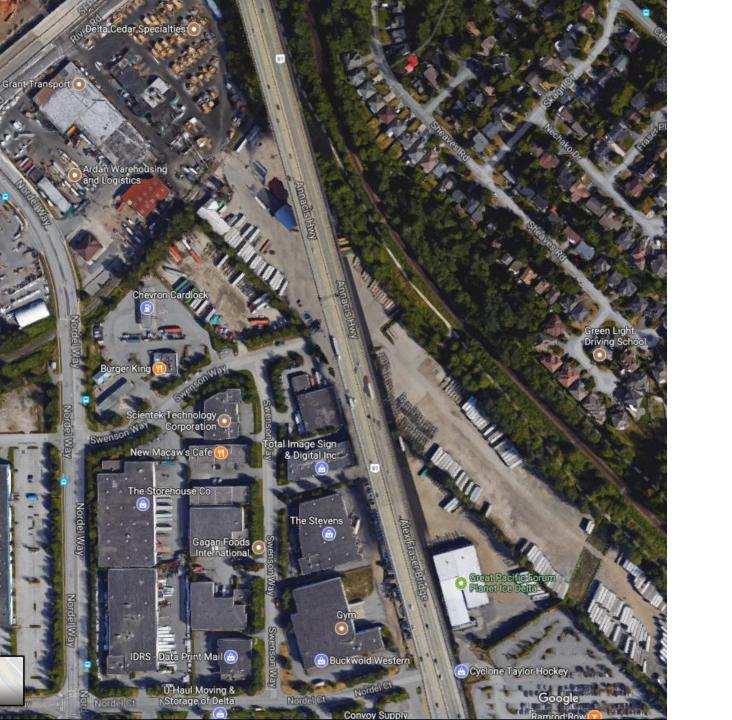
- Widen Path, remove sloughing & Drainage Problems, reduce grade to 5%
- Crossing at Cliveden should be upgraded. Sign pointing in the wrong direction. Adjust sign to have arrow pointing straight towards crosswalk on north side.
- 3. Upgrade signing and access through Cliveden intersection
- 4. Fix sloughing, widen path
- New guide sign at N20. Widen sidewalk locally on West side only
- 6. New guide sign at N15. Widen sidewalk locally, both sides.
- 7. Sign pointing in the wrong direction. Change tab to have arrow pointing left and not right as shown here. (Currently points towards a parking lot)
- 8. Install sign as shown to direct cyclist traffic to bridge.
- 9. Install sign as shown to direct cyclist traffic towards New Westminister and Richmond.
- 10. Install Zw-054R on beginning of fencing. Flare Hand Rail
- Install Zw-054L on beginning of fencing. Fix trail. Flare Hand Rail

- 12. Existing guide sign at Nxxx. Widen sidewalk locally
- 13. Install Zw-054L on first bridge pillar in SB direction.
- 14. Install Zw-054R on first bridge pillar in SB direction.

- 15. Existing guide sign at Nxxx. Widen sidewalk locally
- 16. Install Zw-054R on first bridge pillar in NB direction.
- 17. Install Zw-054L on first bridge pillar in NB direction.

18. Improve Access, Widen Path, Repave, lower grade.

Retaining wall, relocate lamp standard, shrub trimming, flare/widen switchback

- 19. Improve Access, Widen Path, Repave, lower grade (replace bricks with paved path). Retaining wall, flare/widen switchback
- 20. Keep existing sign and cut shrubbery so that sign is not obstructed.
- 21. Keep existing sign (Nordel way east/river road) and install new guide sign (highway 17, ferries, etc.).
- 22. Keep existing sign (Nordel way east/river road) and install new guide sign (highway 17, ferries, etc.).
- 23. Keep existing sign (Alex Fraser Bridge/River Road) and install new guide sign (highway 17, ferries, etc.).
